ADDENDUM NO. 2

September 13, 2023

**CORPORATE DRIVE RECONSTRUCTION
PORTSMOUTH, NEW HAMPSHIRE**

11. Section 1008.1 – Utility Adjustments

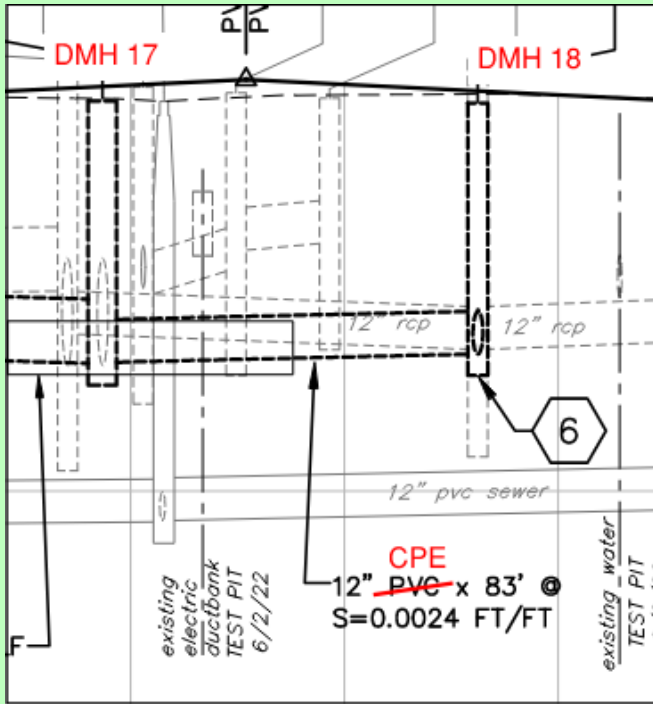
Delete paragraph 4.3.2 and **Replace** with the following:

4.3.1.1. Repair of utilities that are marked by Dig-Safe will be measured for payment only when the utility is found to be more than 1.5’ outside the Tolerance Zone as marked in the field. Tolerance Zone will be as defined in the dig safe regulations (Puc 800 in the NH Code of Administrative Rules).

4.3.1.2 Repair of utilities indicated on the Drawings will only be measured for payment when the utility is found to be more than 6’ from the location shown on the Drawing.

12. Drawing C5 Profile -12" Drain Pipe Between DMH 17 and DMH 18 (STA 57+93 to 58+81)

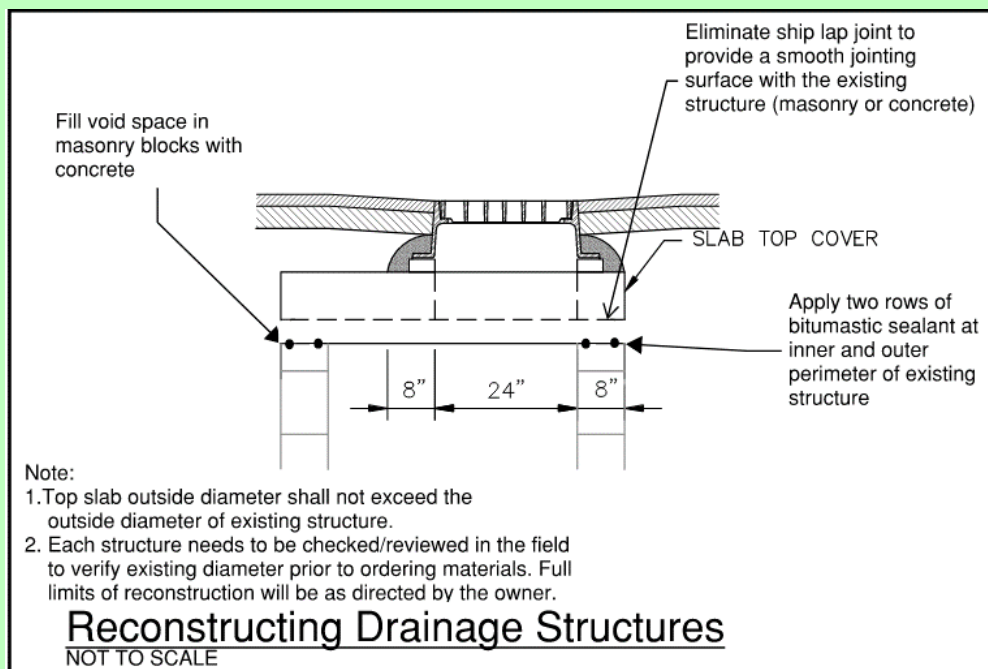
Delete the word "PVC" after 12" and **Replace** with "CPE" as shown below:

14. Drawing D5 Drainage Details -Aggregate Underdrain

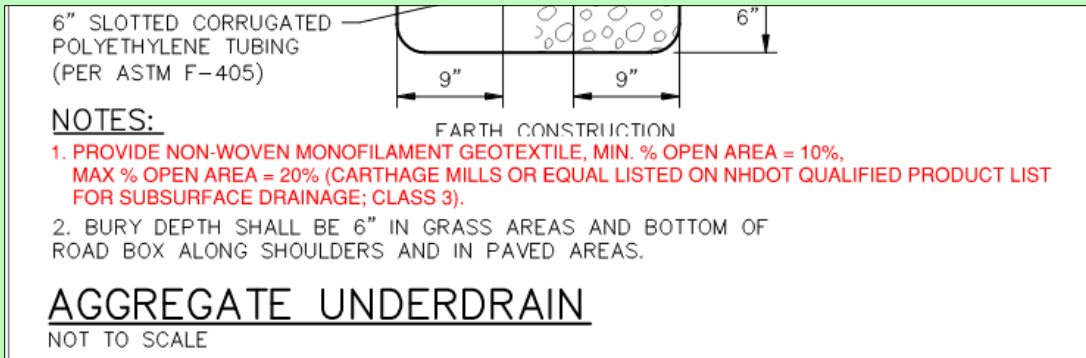
Modify Note No. 1 as shown below:
